SUBJECT: Forwards response to request for addl info re draft SER open items & safety review questions.

SHEARON HARRIS NUCLEAR POWER PLANT
UNIT NOS. 1 AND 2
DOCKET NOS. 50-400 AND 50-401
RESPONSES TO REQUESTS FOR ADDITIONAL INFORMATION

LIST OF OPEN ITEMS/SAFETY REVIEW QUESTIONS, REVIEW BRANCH AND REVIEWER

FIGURE 1-2 UPPER INTERNALS ASSEMBLY

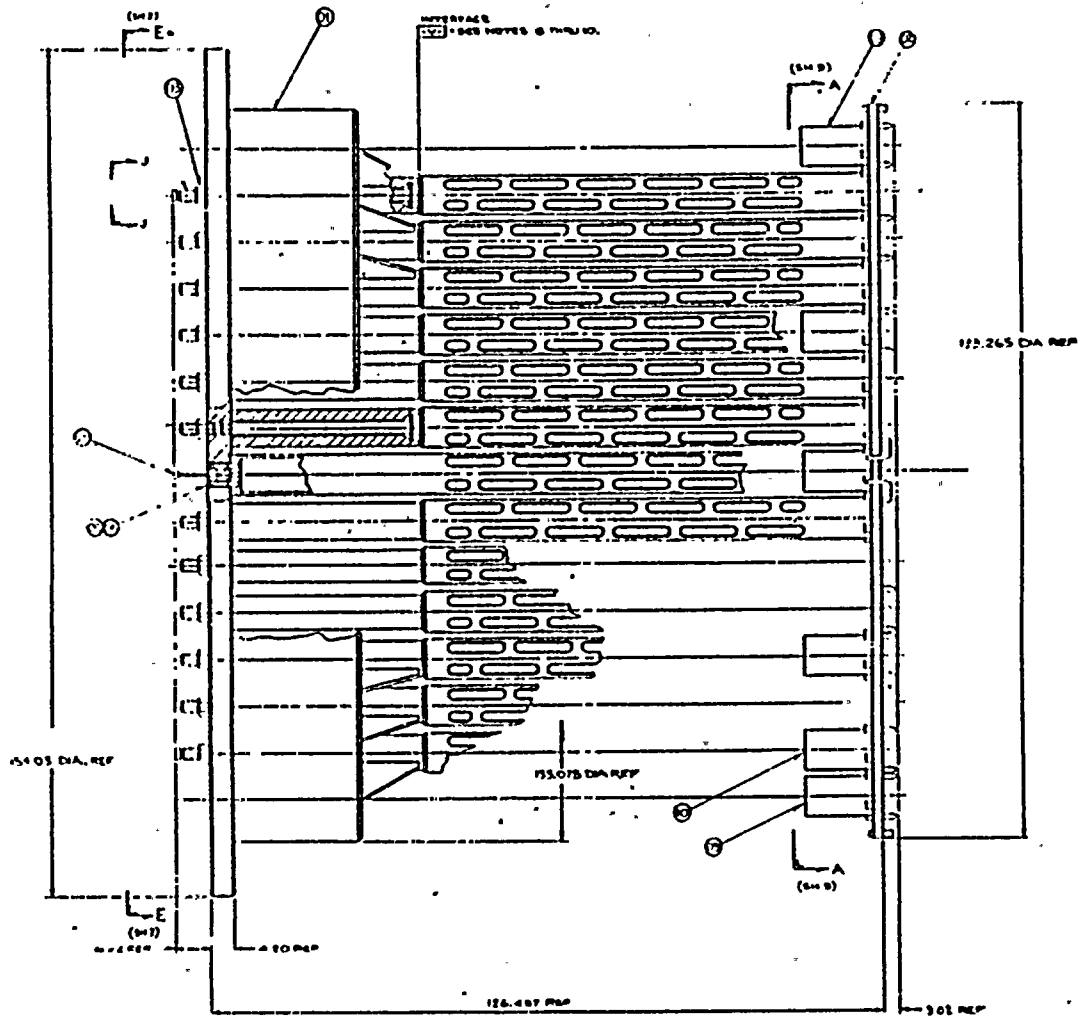
Provide the reactor vessel internals drop analysis in accordance with the guidelines of NUREG-0612, Control of Heavy Loads.

In evaluating the consequences of the upper internals drop analysis for the Shearon Harris Nuclear Power Plant, a series of drop scenarios are postulated. For the purpose of clarity, Figure 1-1 through 1-3 show the refueling canal elevations, the upper internals assembly and the 17 x 17 fuel assembly for the Shearon Harris Power Plant. In the following we shall discuss briefly the drop scenarios and their consequences.

The assembly weight of 140,000 lb_f falls 23.75 feet through water and impacts on the top of the core hold-down spring and core barrel flange assembly which is supported at the vessel ledge. The idealized spring-mass system of the struck body (i.e., core hold-down spring, barrel flange, vessel and nozzle supports) is able to absorb all the kinetic energy of the dropped assembly without over stressing the system. The calculated impact load at each nozzle is 7.3×10^6 lb_f resulting in vessel nozzle pad bearing stress to be 23,400 psi which remains elastic and is well below the code allowable of $2\sigma_y = 100,000$ psi.

DEPT. NO. _____
OFS NO. FIG. 114-1

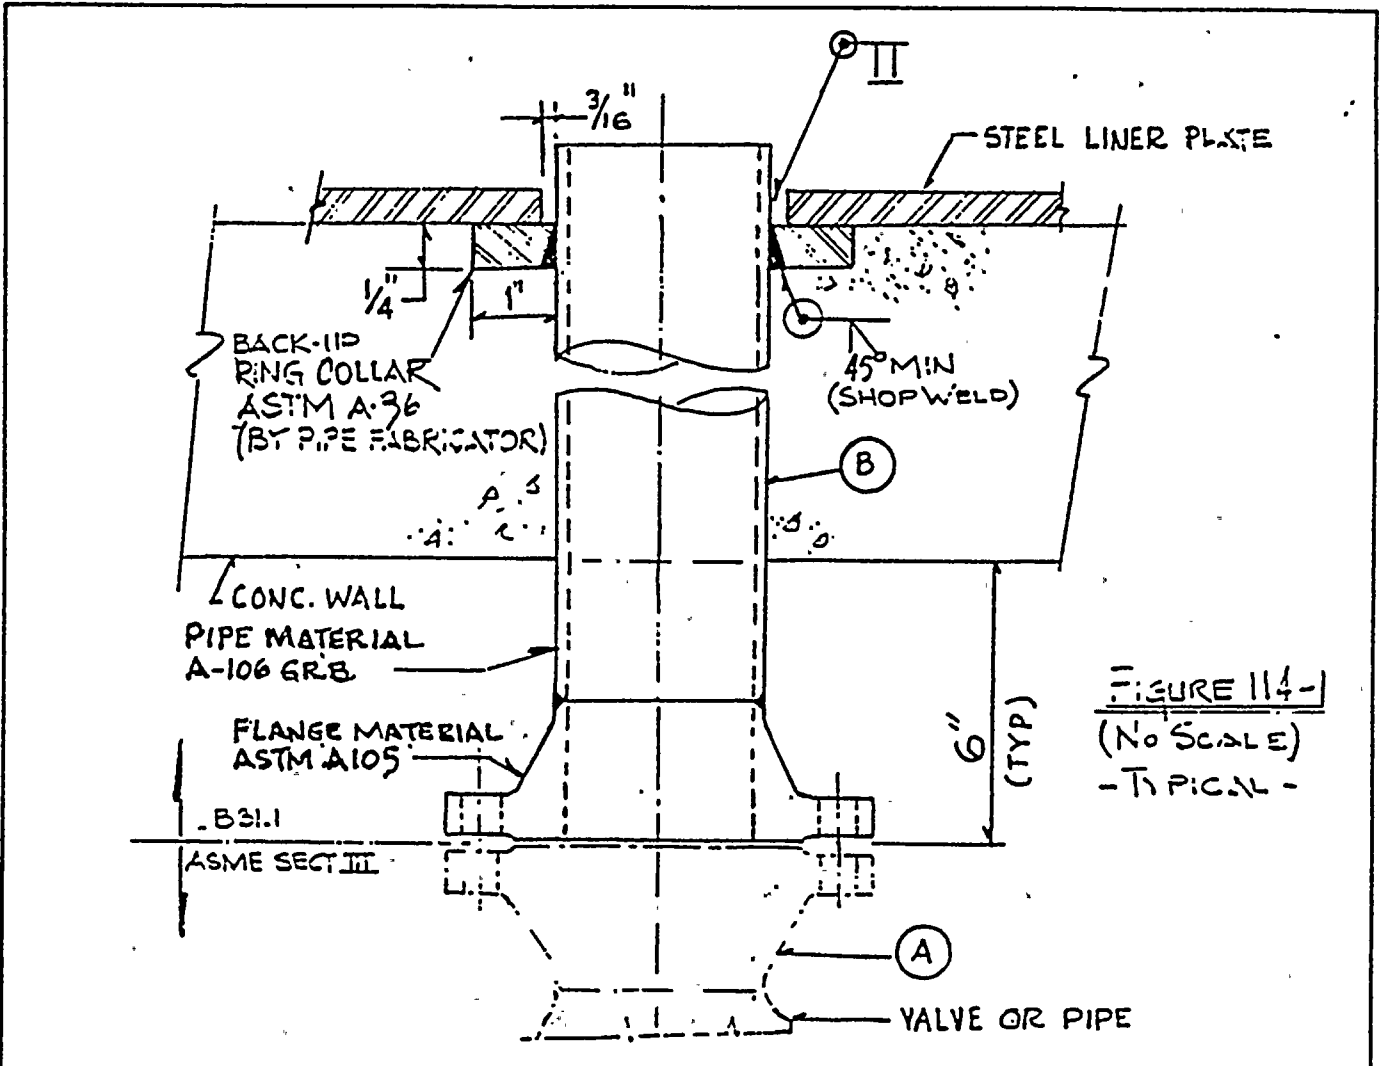
NRC is concerned with fuel oil storage tank piping that interfaces with the tank liner. NRC considers the liner nozzle as part of the piping, therefore, it should be ASME Section III Class 3, Seismic Category 1. Since the pipe and tank are already fabricated, provide information indicating that piping nozzle is functionally equivalent to ASME III, will have adequate inspection, and that stress calculations show that it is within allowable limits. Confirm piping to liner is at least B31.1, QA applied is 10 CFR 50 Appendix B.

Figure 114-1 provides a typical detail for piping interfacing with the fuel oil storage tank liner. The piping interfacing with the liner is B31.1, A 106 GrB up to the mating flange which is ASTM A-105. The piping passing through the storage tank wall is provided with a backing collar which is welded to the pipe. The collar is welded to the tank liner. In our analysis of the piping System the non-safety portion of the system was modeled and the results were found to be within the allowables of the ASME Code Section III.

SUBJECT FHB - RETAINING WALL - INCLUDING HYDROSTATIC PRESS

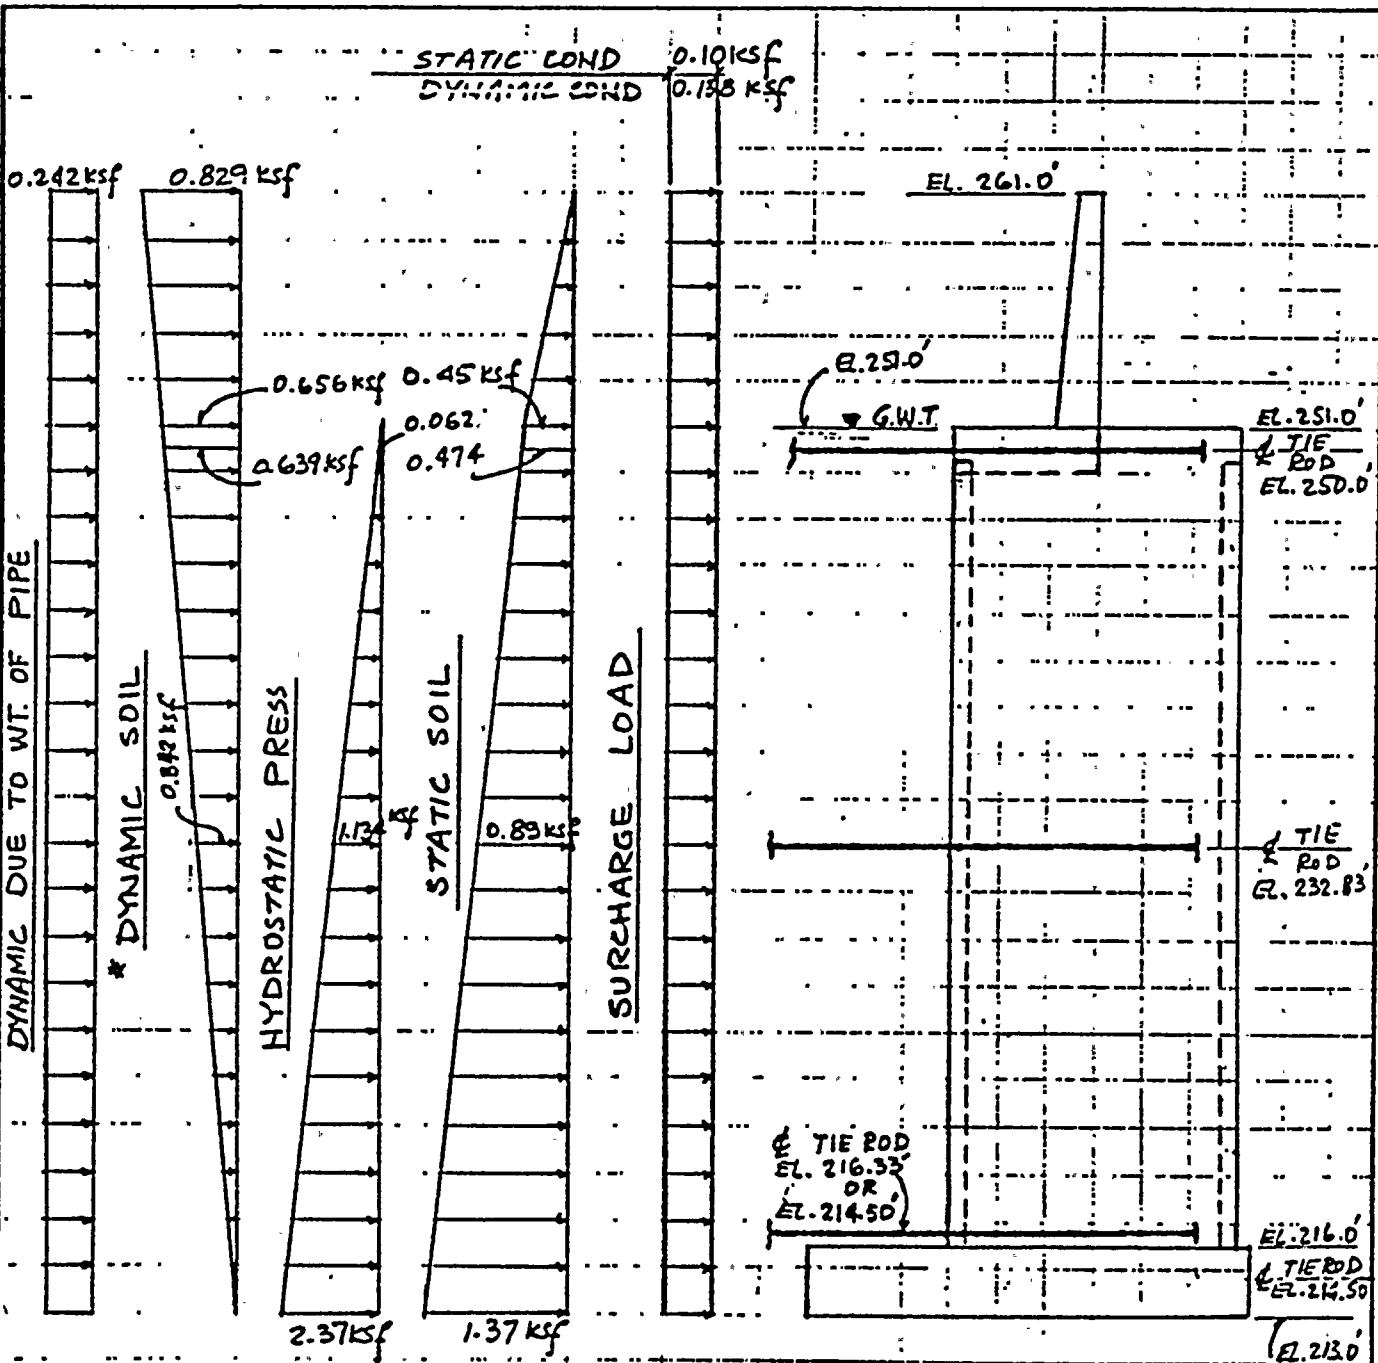
As a result of the cancellation of Units 3 & 4, the reviewer requested additional details relative to the design of the Retaining Wall West of the Fuel Handling Building.

The retaining wall has been designed for static and dynamic SSE seismic load conditions for the lateral soil pressures in combination with hydrostatic pressure, as shown in the pressure diagram (see Attachment No. 1). The wall has been designed for full hydrostatic pressure in case the filters become clogged for any reason even though it is highly improbable since the drainage material, is crushed rock transition filter material in accordance with Ebasco Specification CAR-SH-CH-4 (see FSAR Appendix 2.51). The transition filter material is well graded from minus three (3) inch to sieve #200 (see Attachment No. 2).
